**CITY OF NORTHGLENN**

**City Hall Roof Replacement  
RFP 2018-026**

**ADDENDUM NO. 1**

DATED: December 4, 2018

**See attached roof dimension drawing.**

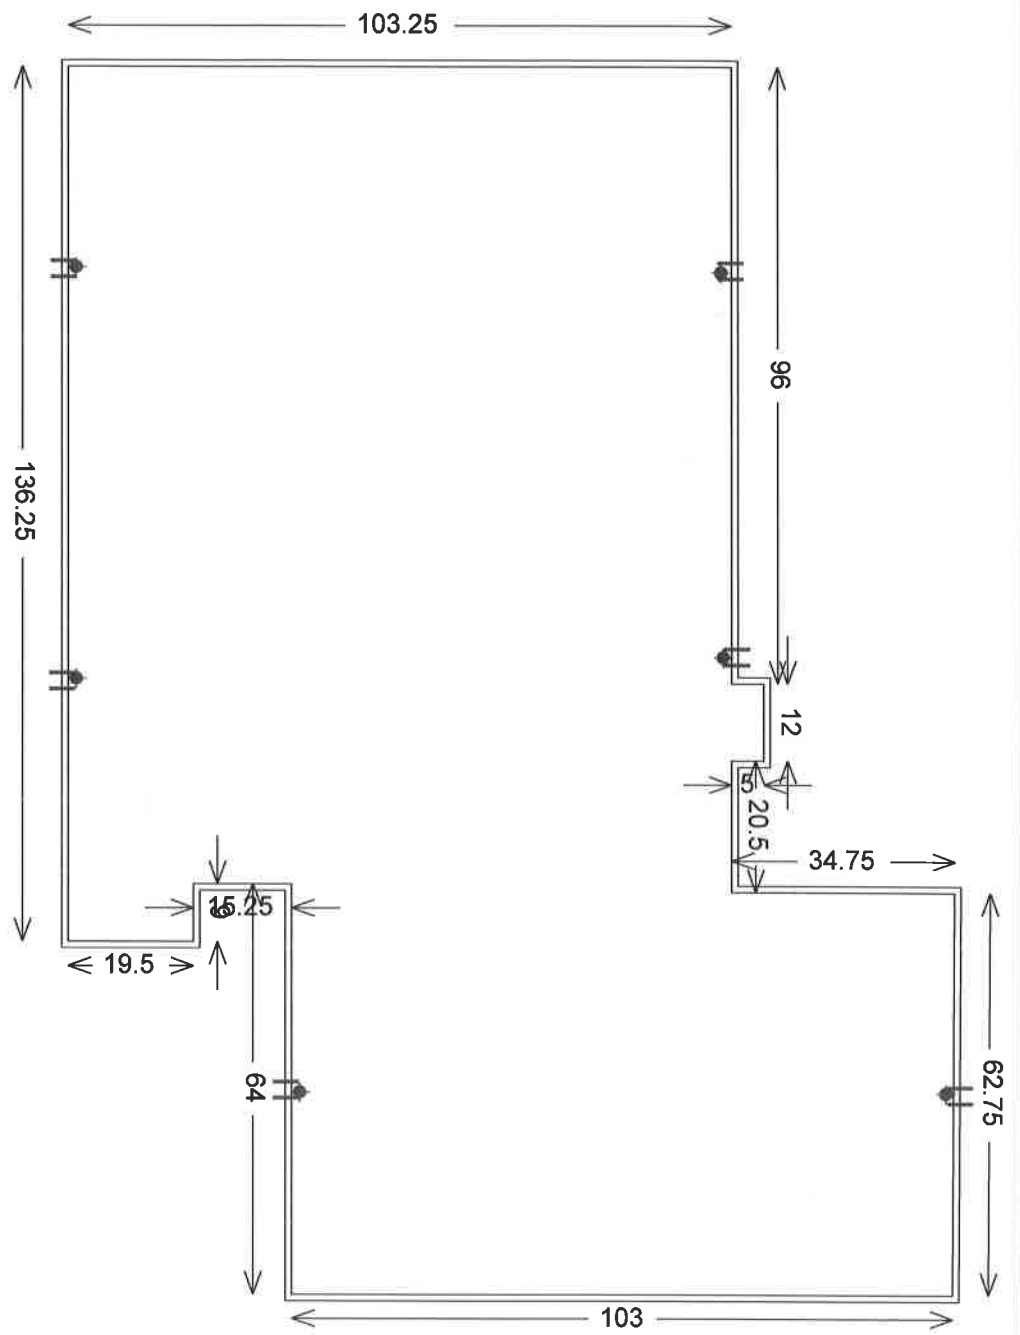
*All bidders are responsible for their own dimensions, but this is believed to be correct*
